# ADDENDUM A Staff Report: Z-60-16-7 September 28, 2017

Request To: R1-6 PCD (145.40 acres)

Proposed Use: Planned Community District to all

**Location:** Northeast corner of San Juan

CONCEPTUAL DEVELOPMENT PLAN

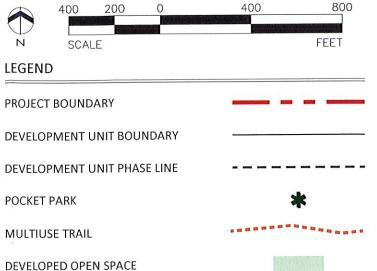
The location and boundaries of the seven development units will be in general conformance to the Conceptual Development Plan date stamped August 2, 2017. This is addressed in Stipulation 11.

- 11. THE DEVELOPMENT OF THE SITE SHALL BE IN GENERAL CONFORMANCE WITH THE CONCEPTUAL DEVELOPMENT PLAN DATE STAMPED AUGUST 2, 2017, WITH SPECIFIC REGARD TO THE LOCATION AND SIZE OF THE SEVEN DEVELOPMENT UNITS, AS APPROVED BY THE PLANNING AND DEVELOPMENT DEPARTMENT.
